BROOKHAVEN NATIONAL LABORATORY  
ASSOCIATED UNIVERSITIES, INC.

March 1, 1985

## ATTACHMENT 1

### REQUEST FOR INFORMATION

FIG. 6.2.1-4

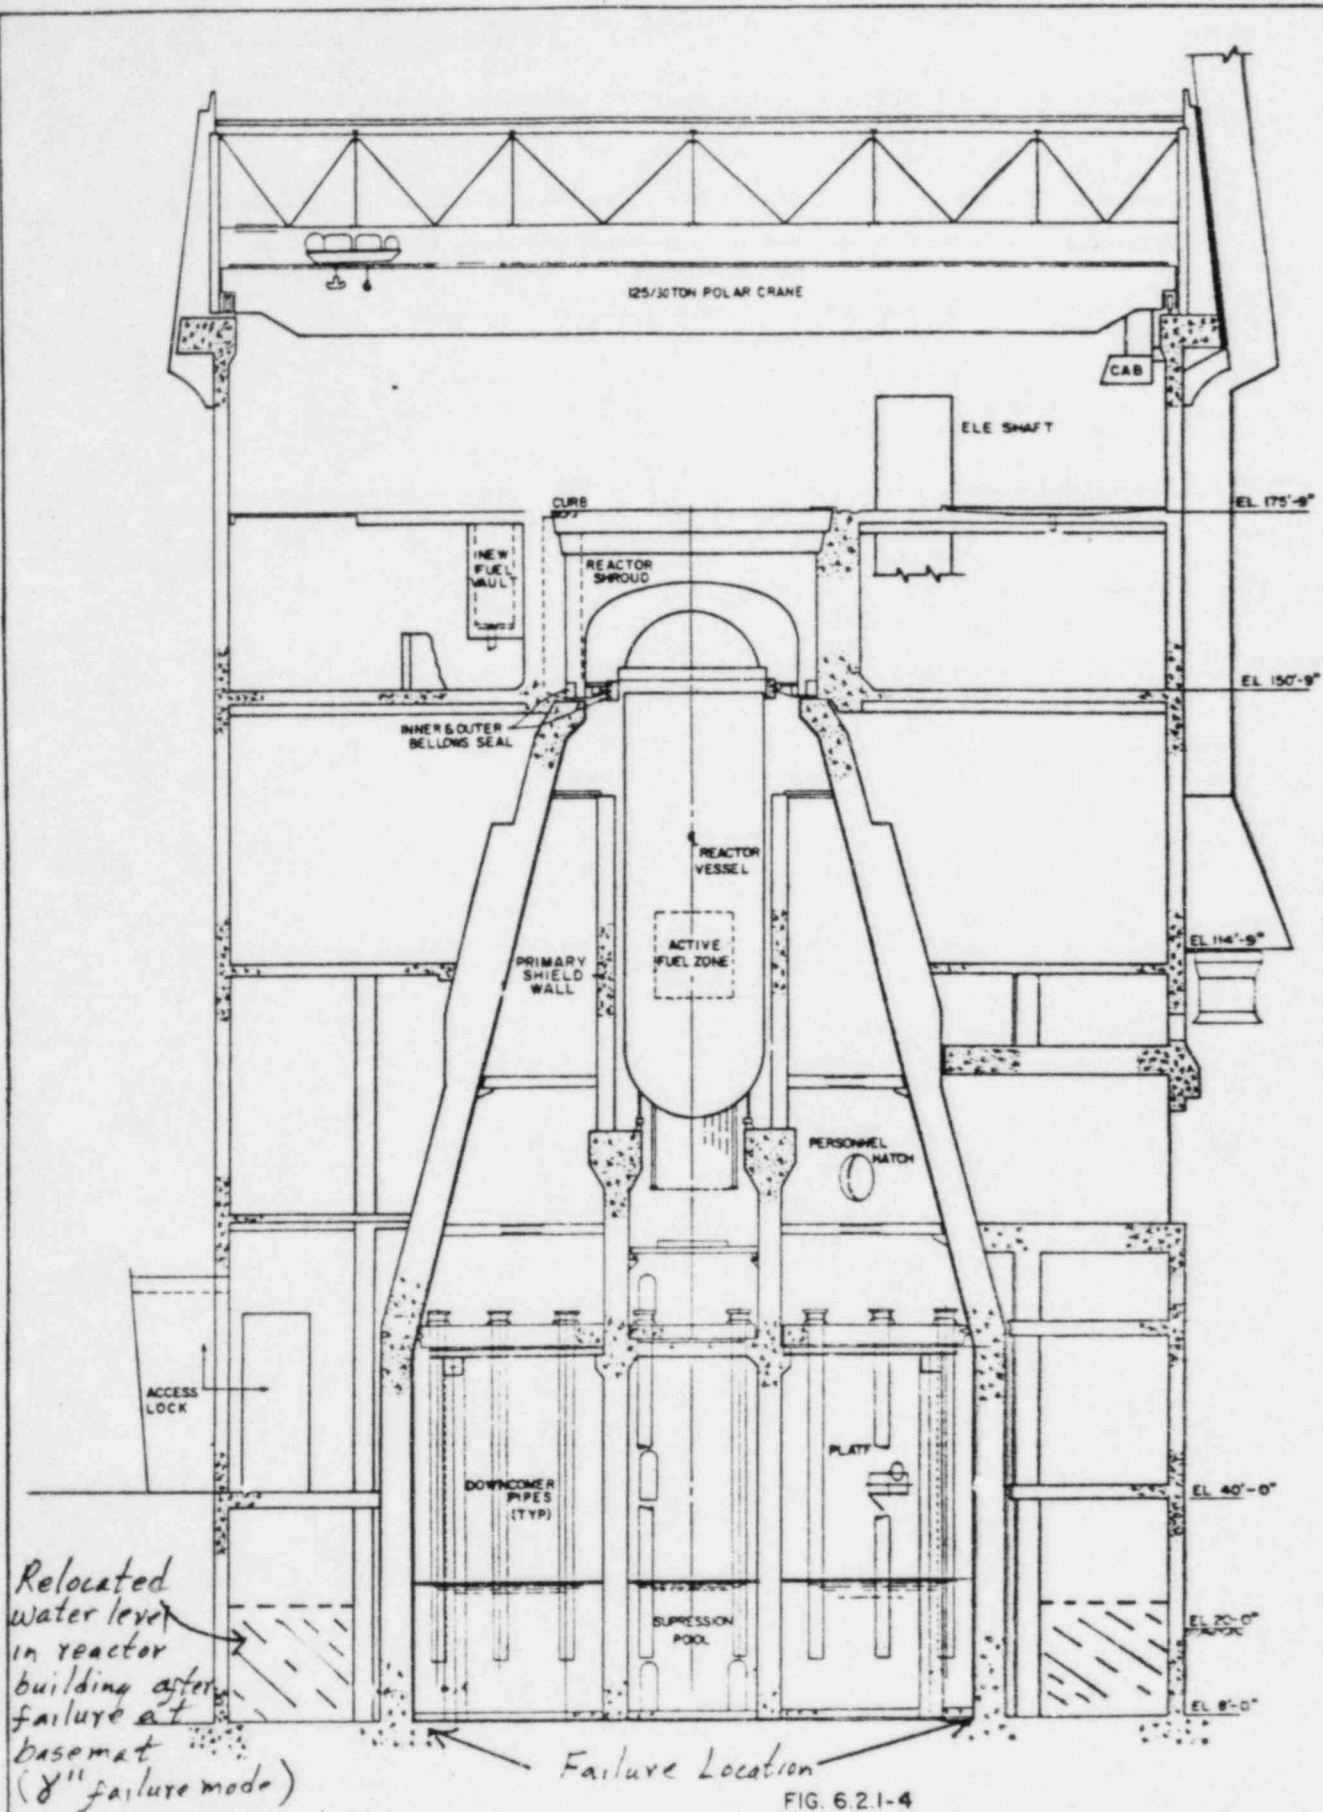
Note that 16% of pool is estimated to be vaporized during blowdown of primary containment after 8" failure
